# Access Compliance Report

## Public Rights-of-Way

Intersection ID: 12428	Main Street: E_7TH_ST	Cross Street: N_CALDWELL_ST	Location: E
ADA ID: 031A28CDA333	Ramp Type: PerpDiag	Initial Pass/Fail: Fail	Overall Compliance: No
		Severity Score: 10

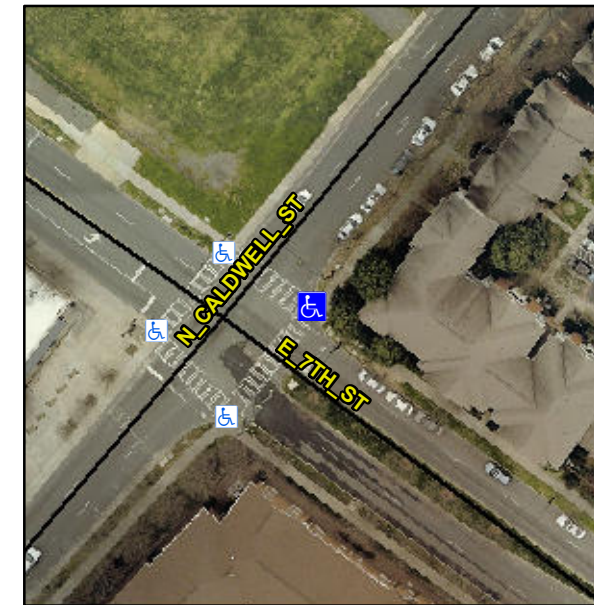
**R304.5.1, R304.5.3**

Compliance	Description	Data	Compliance	Description	Data
N/A	Ramp Length (in)	84.0	Yes	Ramp Slope (%)	6.8
No	Ramp Width (in)	41.0	No	Ramp XSlope (%)	2.2
N/A	Flare Type LT	N/A	N/A	Flare Type RT	N/A
N/A	Flare Slope LT (%)	N/A	N/A	Flare Slope RT (%)	N/A
N/A	Flare Traversable LT?	N/A	N/A	Flare Traversable RT?	N/A
N/A	Landing Length (in)	N/A	N/A	DWS Provided?	N/A
N/A	Landing Width (in)	N/A	N/A	DWS Contrast?	N/A
N/A	Landing Slope (%)	N/A	N/A	DWS Length (in)	N/A
N/A	Landing X Slope (%)	N/A	N/A	DWS Full Width?	N/A
N/A	Landing Curb? (Y/N)	N/A	N/A	DWS Offset (in)	N/A
N/A	Shared Landing?	N/A			
N/A	Gutter Ponding?	Yes	N/A	Gutter Slope (%)	N/A
N/A	Gutter Lip Ht (in)	1.0	N/A	Gutter X Slope (%)	N/A
N/A	Painted X Walk1?	Yes	N/A	Painted X Walk2?	Yes
	X Walk 1 Direction	To NW		X Walk 2 Direction	To SW
N/A	X Walk 1 Width (in)	130.0	N/A	X Walk 2 Width (in)	85.0
	X Walk 1 Slope (%)	3.5		X Walk 2 Slope (%)	0.0
	X Walk 1 X Slope (%)	2.3		X Walk 2 X Slope (%)	3.0

**Remove & Replace Curb Ramp With Two New Directional Ramps or Equivalent.**
